**BEFORE THE PUBLIC UTILITY COMMISSION
OF OREGON
PCN-2**

In the Matter of the Petition of)
)
TILLAMOOK PEOPLE’S UTILITY)
DISTRICT)
)
**PETITION FOR CERTIFICATE OF)
PUBLIC CONVENIENCE)
AND NECESSITY)**
)
)
_____)

INTERVENOR REPLY TESTIMONY OF DAVID MAST

March 11, 2019

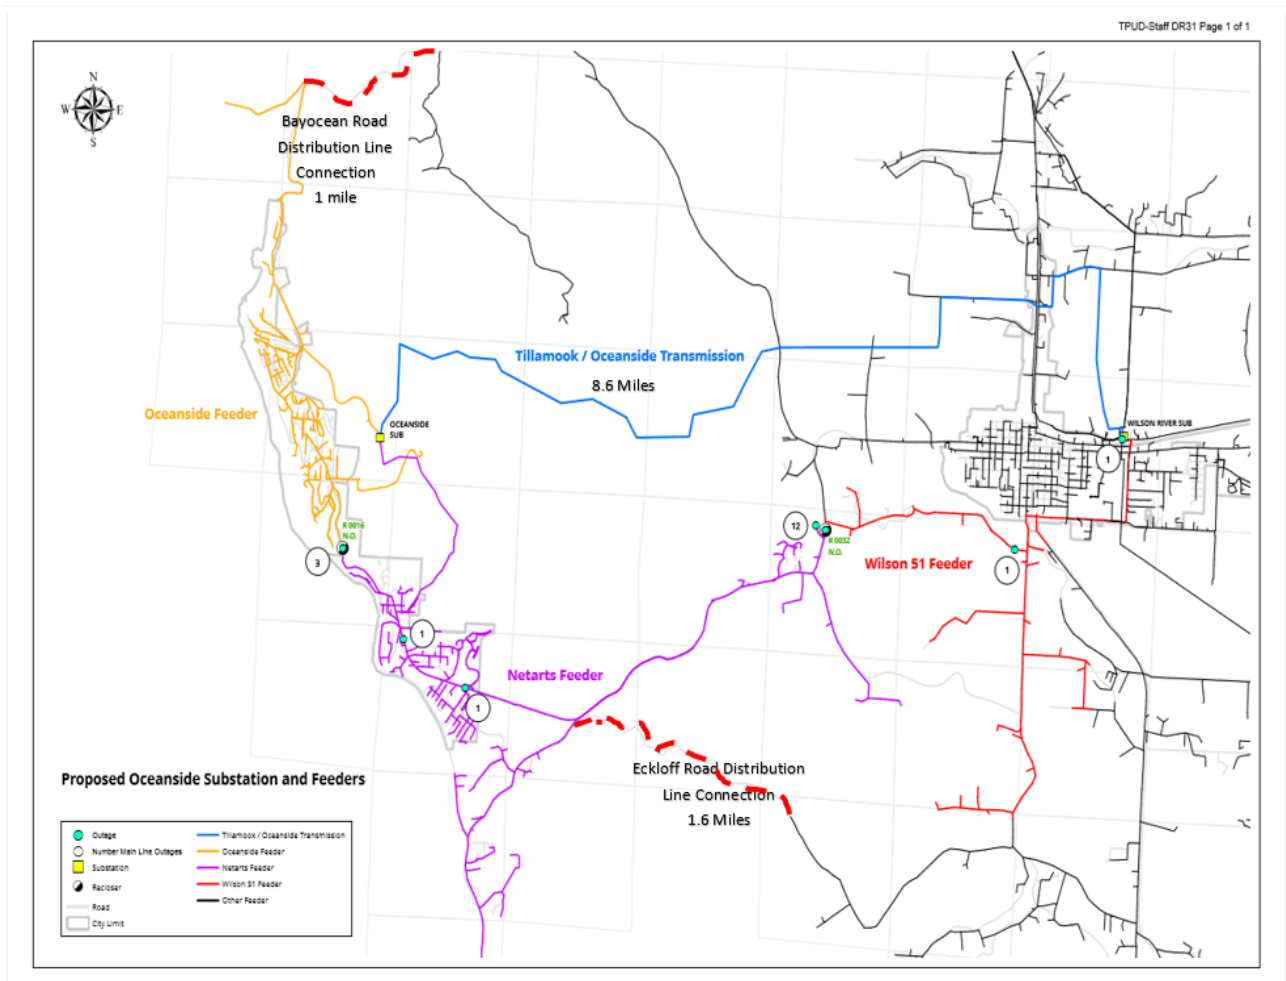
The Trask substation is only loaded at 12% of capacity and the highest coincident peak at the Trask was only 47% of capacity.¹⁰ Moving feeder 51 to the Trask would relieve 5 – 12 MW from the Wilson River T1 & T2 and it would put the Task at a more efficient level. The \$16 M transmission line/substation is planned to take load off the Wilson Rivers. Total system capacity and central valley capacity is not an issue. Moving feeder 51 to the Trask accomplishes the same thing for significantly less cost. Moving feeder 51 and 5 – 12 MW to the Trask along with the additional 12 MW from the larger transformer for Wilson T1 provides similar reliability to that of the transmission line. The map below shows how the new distribution line construction would interface the current grid. Instead of 8.6 miles of new transmission line and substation, the same 3 feeder redundancy for Netarts-Oceanside from two different substations is accomplished with 2.6 miles of new distribution line. In addition, the citizens of Cape Meares now have redundancy.
